Preventing clock content issues in 800GBASE-R PCS/PMA

(In support of comments #21, #74 against D1.1)

Adee Ran, Cisco

Figure 49-8—Scrambler

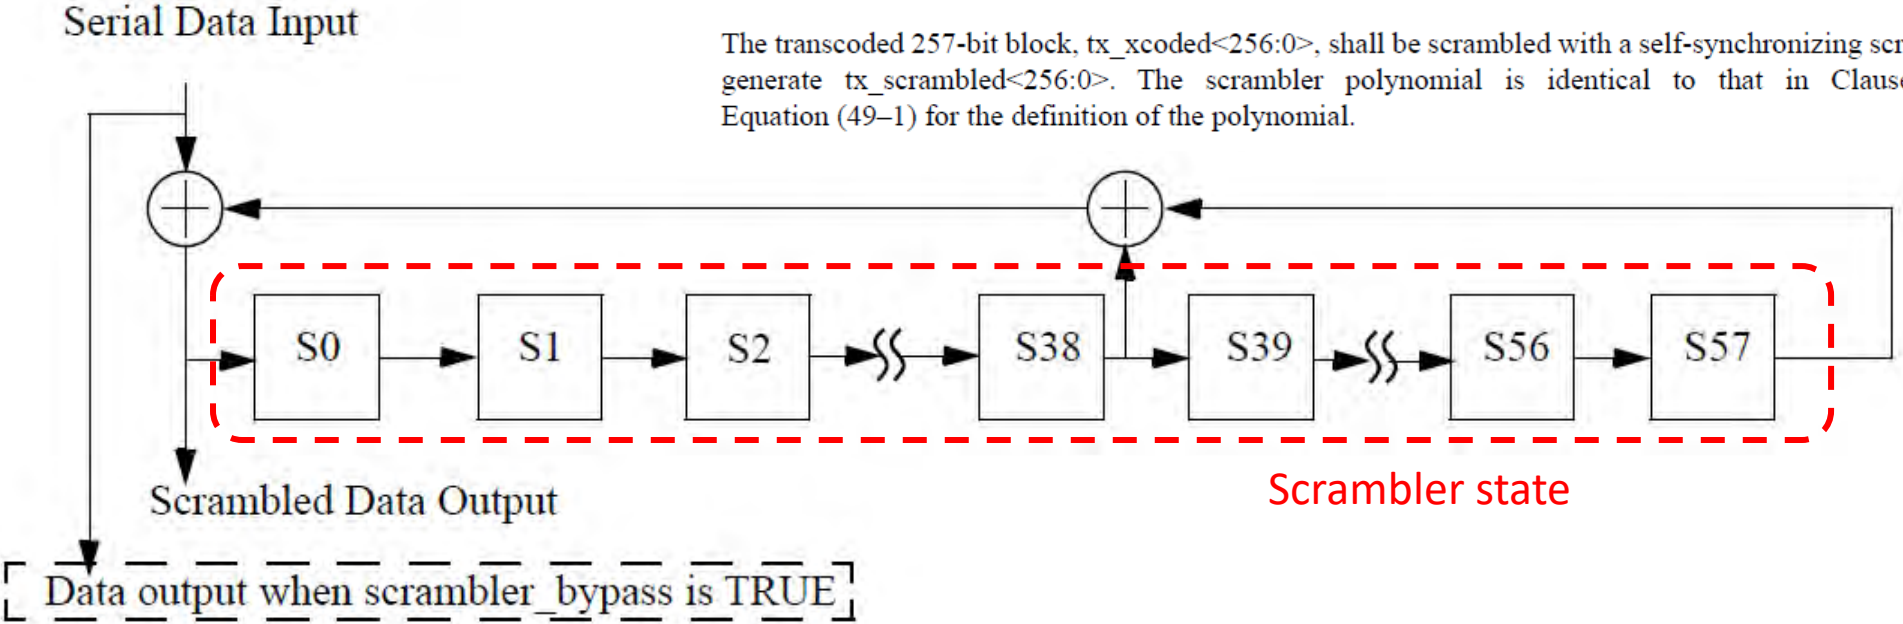
Solution: prevent scrambler from having equal seeds

- The LFSR state is a function of both the previous state and the input.
- With zero input, the LFSR period is $2^{58} - 1 \approx 3 \times 10^{17}$ bit times.

- With a constant non-zero transcoded scrambler input (a periodic sequence with a period of 257 bits), the output will also be periodic
 - 257 is a prime number, and is not a factor of $2^{58} - 1$, so the periods are coprime; the combined period is 257 times longer, $\approx 10^{20}$ bit times

- With a bit time of 2.5 ps (per flow), the period is about 6 years.
 - Different scrambler seeds will create different “random” offsets of the periodic output sequence.

- For a given seed, finding another seed that, with the same input, creates an output with a small offset is “hard”.
- With the same input, the probability that two different initial scrambler states would create outputs separated by a small delay is negligible.

- **Practically, different initial seeds should completely eliminate the problem.**

- A self-synchronizing scrambler does not require initialization.
- It can be implemented with no reset function...
 - “Random” initial values would eliminate the issue
- However, if reset is implemented, synchronous reset of both scramblers to the same value would be bad.
 - We should address possible implementations that reset the scrambler.

172.2.4.3 Scrambler

The scrambler in each flow is identical to that specified in [119.2.4.3](#).

Although there is no requirement on the initial value of each scrambler, if an implementation sets the scrambler state to a fixed value (e.g., when reset is asserted), the two scramblers should be set to different states.
